I-405 MP 26.90 Queensborough Creek (WDFW ID): 993109 Final Hydraulic Design Report – NDC 152

This notice of design change (NDC) modifies the I-405 MP 26.90 Queensborough Creek Final Hydraulic Design Report (FHD). It presents updated bed material gradations and updated scour analyses associated with this change. This report addendum supersedes and replaces the following tables, sections, and figures as specified below.

Figure 4-2: Typical riffle design cross section

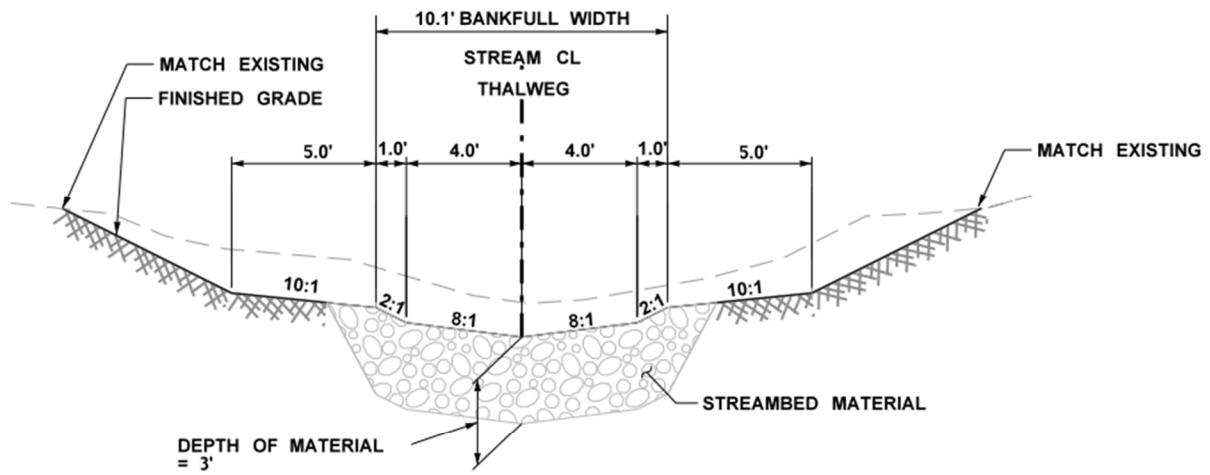
- Updated Figure 4-2 and Figure 4-3.
- Section 4.2 Minimum Hydraulic Opening
 - Updated Figure 4-4.
 - Section 4.2.4 Hydraulic Length updated to include reference to DBIC 049 and discuss the updated hydraulic length.

Cross slopes in riffles are 8H:1V to promote fish passage in low flows with 2H:1V bank slopes extending to the bankfull width of 10.1 feet. The typical pool section has a wider bankfull width to achieve acceptable residual pool depths. Typical pools are pre-scoured and are not anticipated to scour significantly deeper than the as-built condition as indicated by minimal calculated bend scour depths in **Section 7.4.3**. Typical pool sections also include a 10H:1V bench on the inside of meander bends to mimic the formation of point bars (Cramer 2012). The average meander spacing is approximately four times the bankfull width, consistent with Project Technical Requirements.

Figure 4-4: Illustration of minimum hydraulic opening and structure free zone

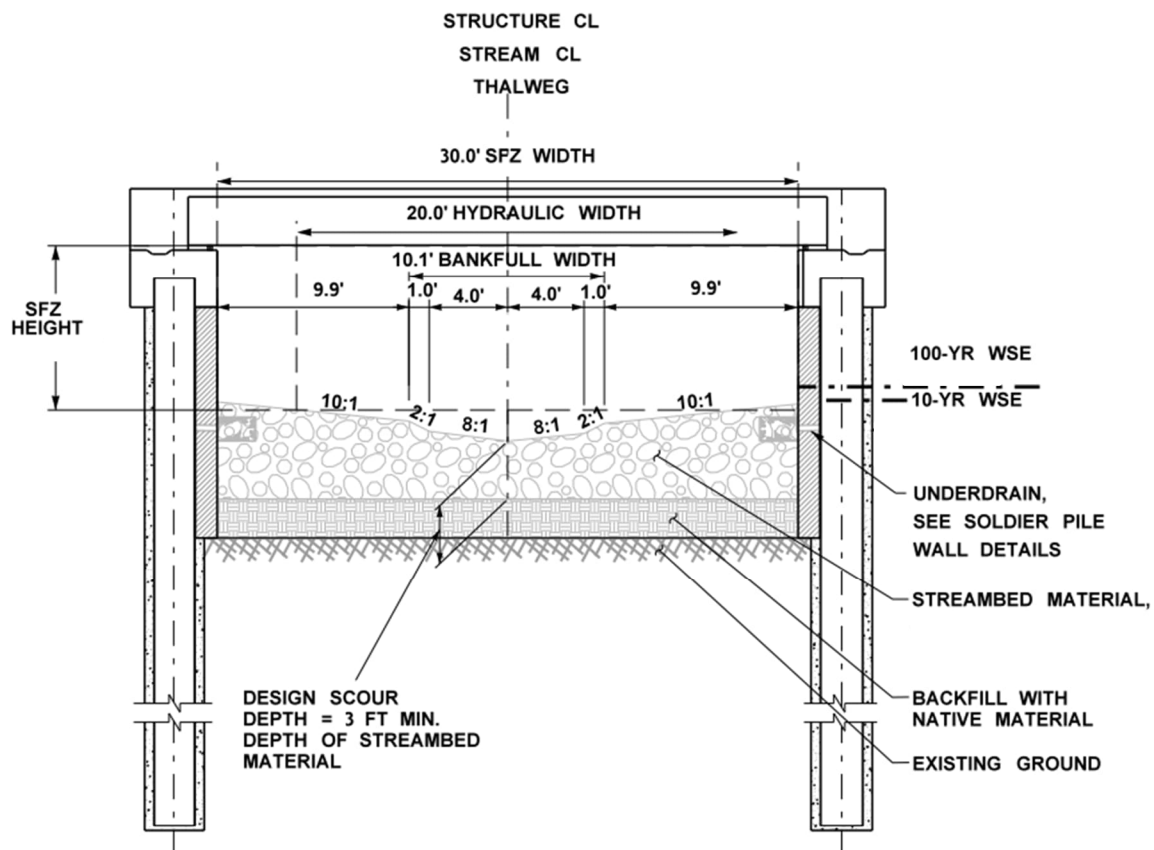
Because the hydraulic length has increased since the preliminary design, the hydraulic width and vertical clearance should be reevaluated. Based on the stream's bankfull width of 10.1 ft, Equation 3.2 of the WDFW 2013 Water Crossing Design Guidelines, and the fact that this crossing is defined as a "long culvert" by WDFW, the minimum hydraulic width was determined to be 20.0 ft. Proposed geomorphic features including large woody material, mobile woody material, and meander bars will be placed in the structure to provide habitat complexity and diversity. Considering the addition of these geomorphic features, a 30-foot structure free zone width was determined for the site.

The wingwall configuration allows for greater than a 30-foot structure free zone width outside of the structure, therefore, the stream will not be confined through the wingwalls. The width of flow during the 2-year storm (a proxy for the dominant channel forming flow) is not confined within the structure or wingwall layout.

Figure 4-5: Downstream layout of habitat complexity features

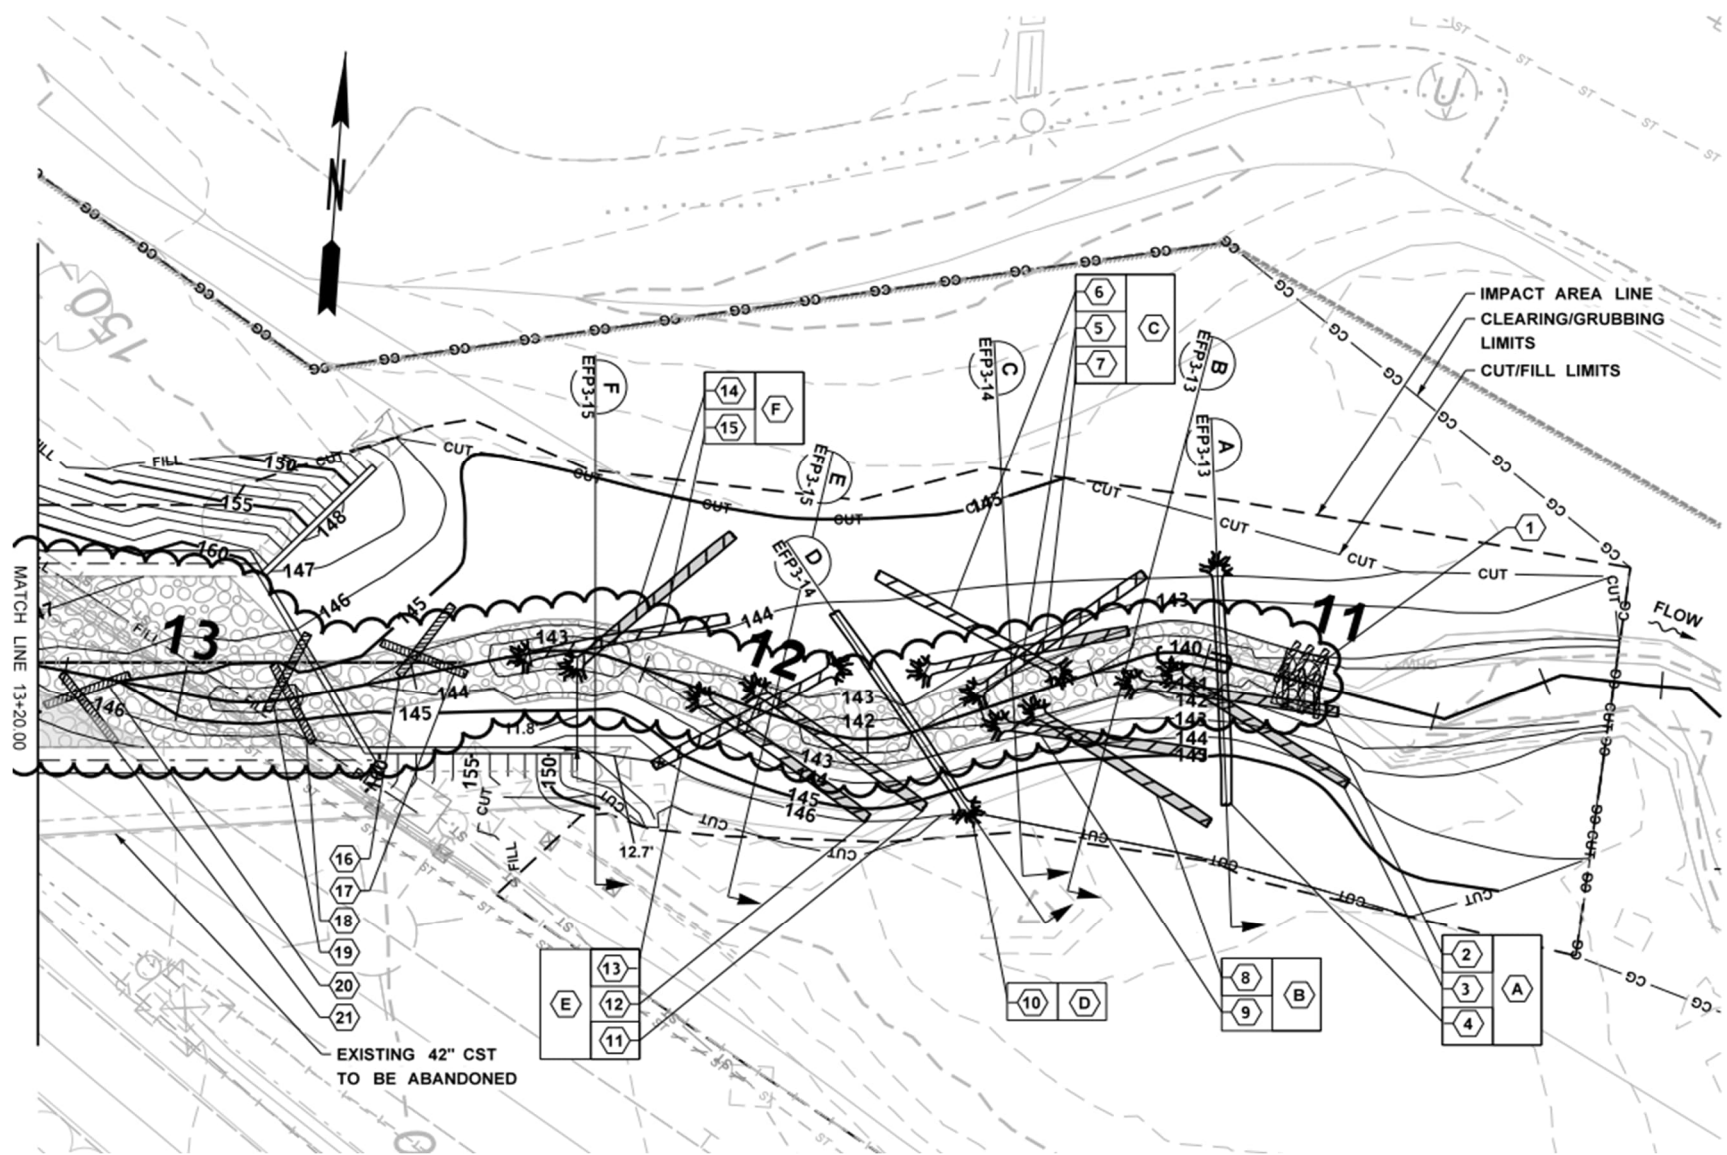
- Section 4.3.2 Channel Complexity
 - Subsection 4.3.2.1 Design Concept, Figures 4-5, 4-6, and 4-7 revised.
 - Subsection 4.3.2.3 Meander Bars revised to remove reference to previous Type II Streambed Material and discuss meander bar material gradation.

The three channel complexity elements will be incorporated into the channel design to meet the functional goals, as described in more detail in the following subsections and seen in **Figure 4-5**, **Figure 4-6**, and **Figure 4-7** (see **Appendix D**).

Figure 7-3: Location of meander bends evaluated for bend scour

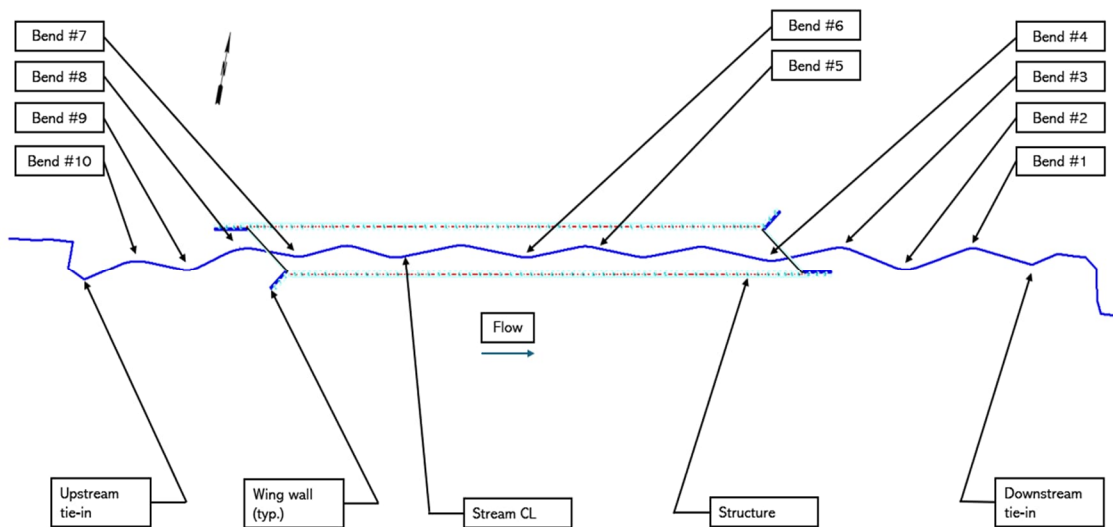
- Subsection 7.4.3 Bend Scour revised.
- Section 7.5 Total Scour
 - Updated total scour values in text.
 - Updated Table 7-2.
- Section 9 Summary
 - Updated Table 9-1 potential channel degradation value.

The bend scour equations used are empirical and were developed based on flows at or below the bankfull condition and are generally valid up to significant interaction between main channel and overbank flows (USACE 2025; WDFW 2012). Due to this, bend scour was evaluated using the 2-year flow. **Figure 7-3** shows the location of the bends analyzed.

However, the proposed channel will have pre-scoured pools that dissipate hydraulic energy, resulting in a 1.0-foot residual pool depth at every meander bend. The estimated maximum bend scour, beyond the 1.0-foot residual pool depth, is 0.8 feet.
